CLIENT Reading Borough Council - Mr S Hicks
PROJECT Cemetery Arch
Repair Schedule
DRAWING Roof Plan and Internal Elevations: Phase 1 and 2

STATUS CONSERVATION MARK-UP
SCALE 1:50
DRAWN CD
CHECKED NO
3959/202
REV B
DATE Sept 2024

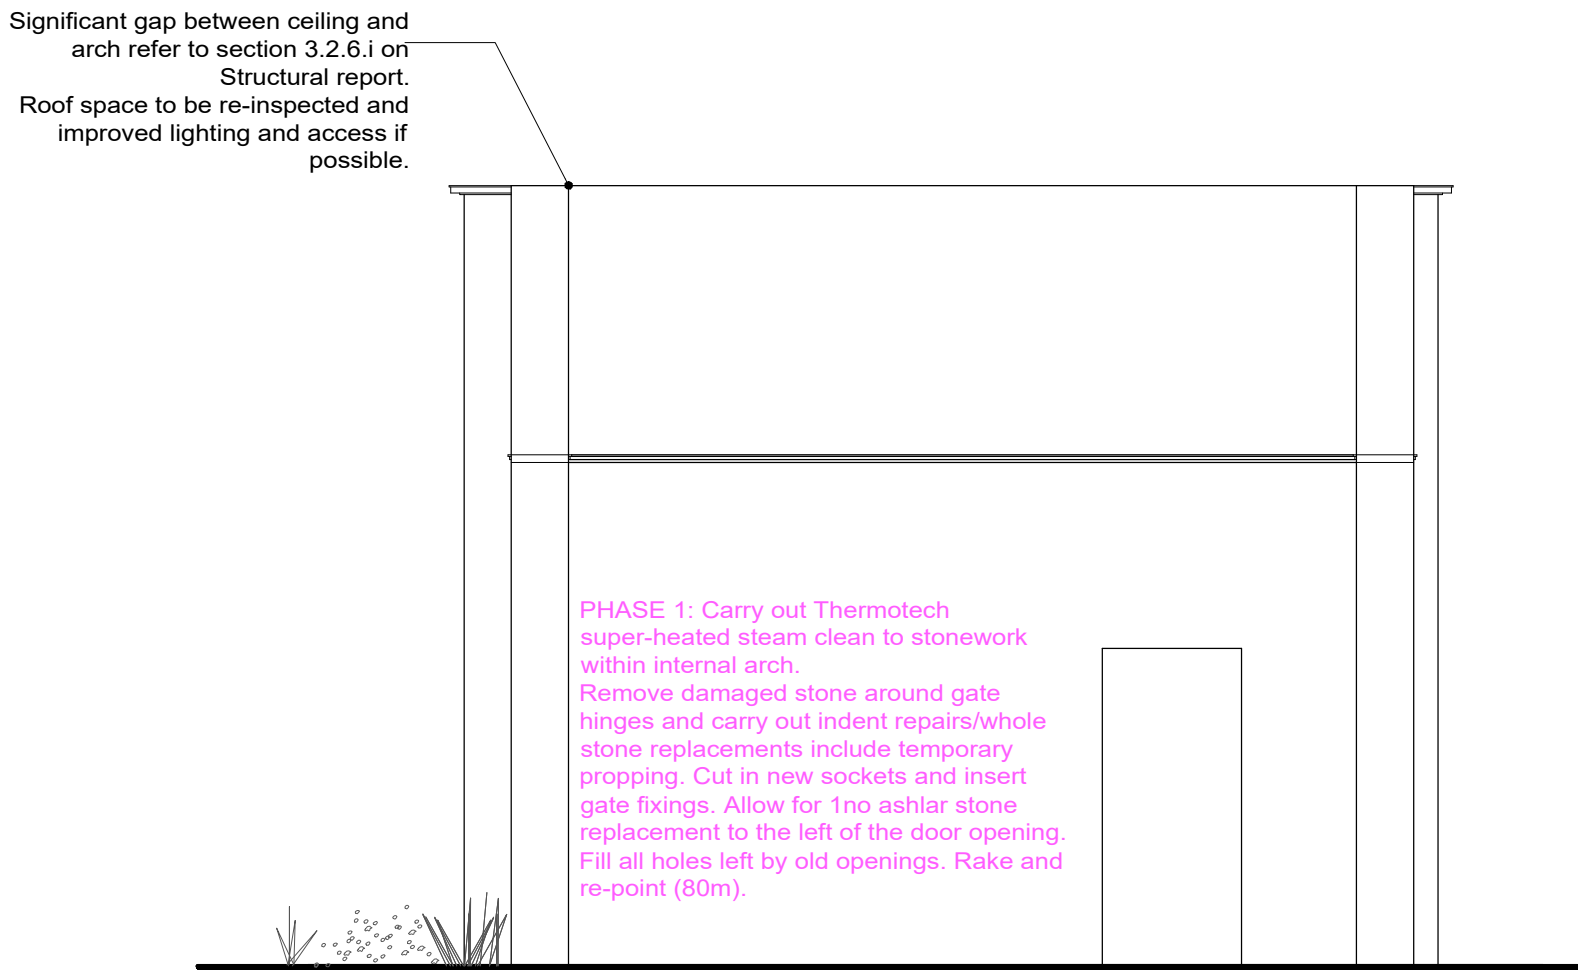
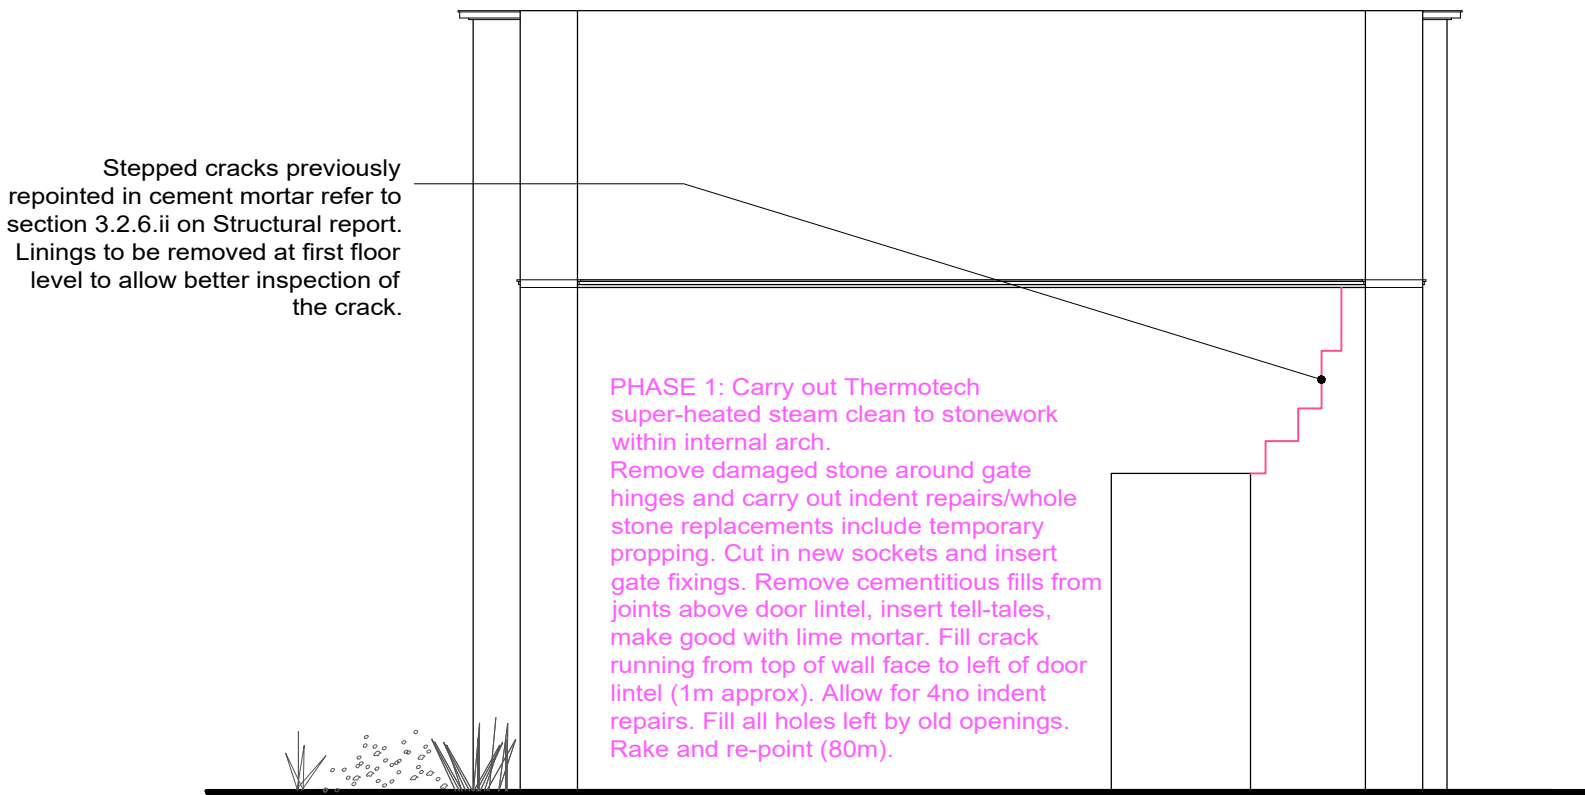
NOTES:
FOR ALL INTERNAL REPAIRS TO ROOF PLEASE REFER SECTION 3.2.7 ON STRUCTURAL REPORT.

FOR ALL REPAIRS TO INTERNAL ROOMS REFER SECTION 3.2.8 ON STRUCTURAL REPORT.

Roof Plan

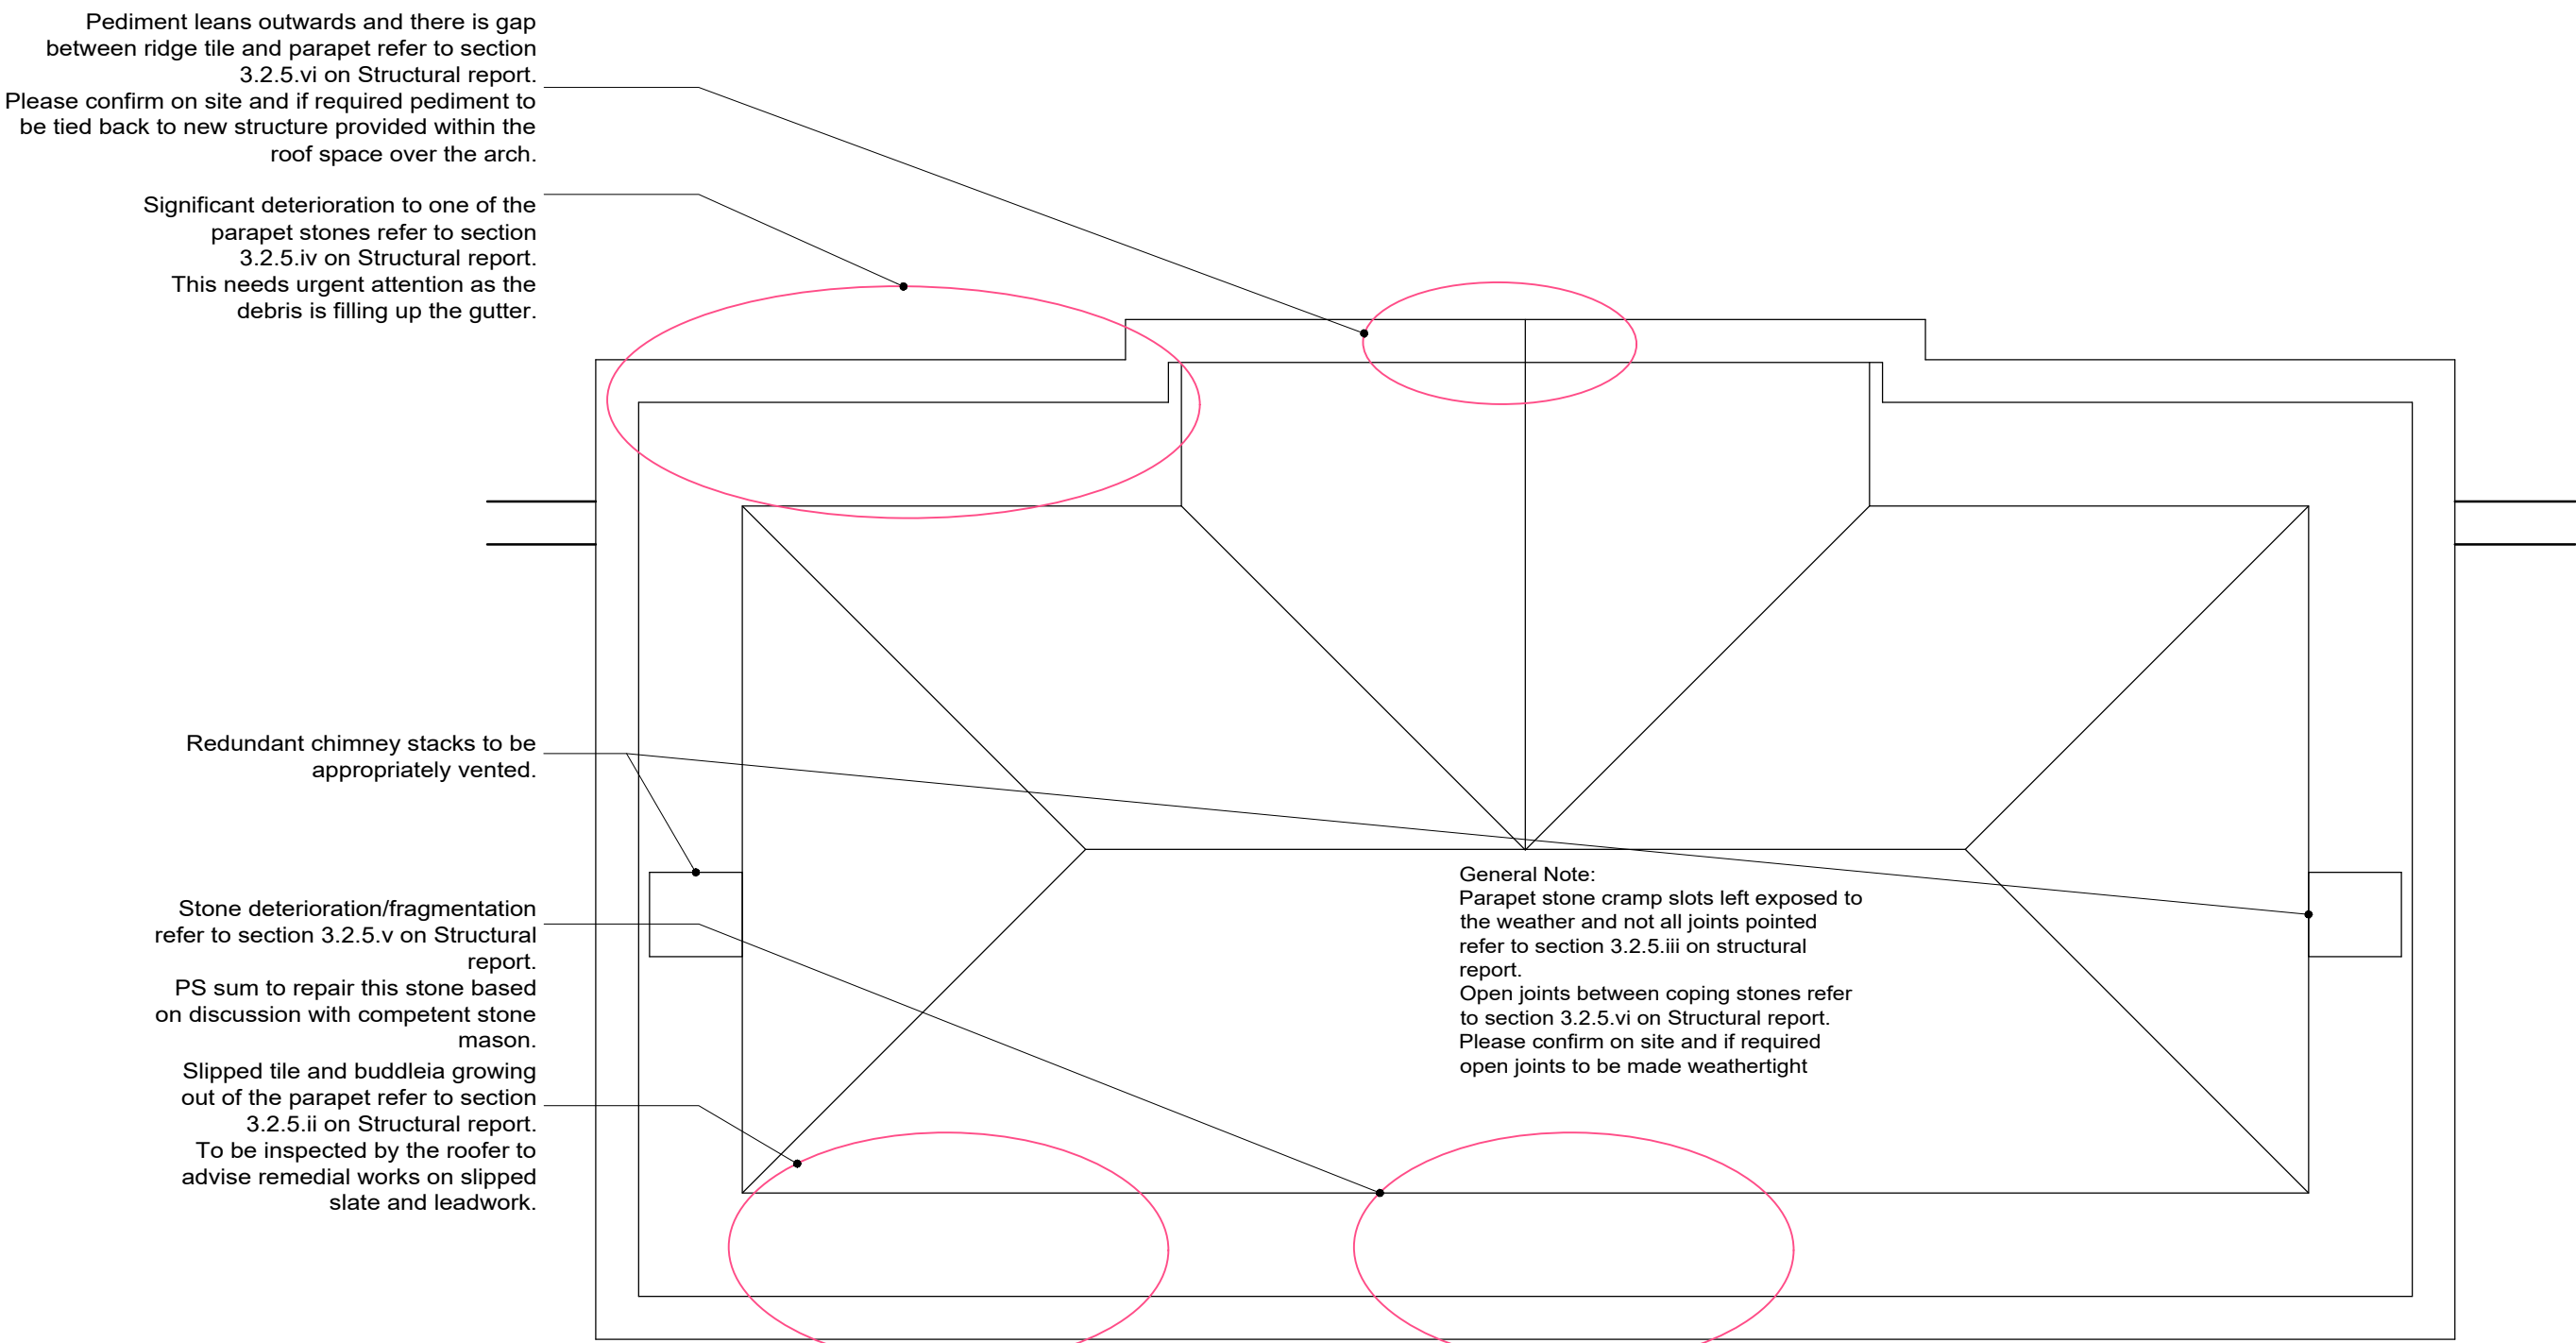
PHASE 1: To inspect all areas of pediment and parapets from roof gully once accessible.
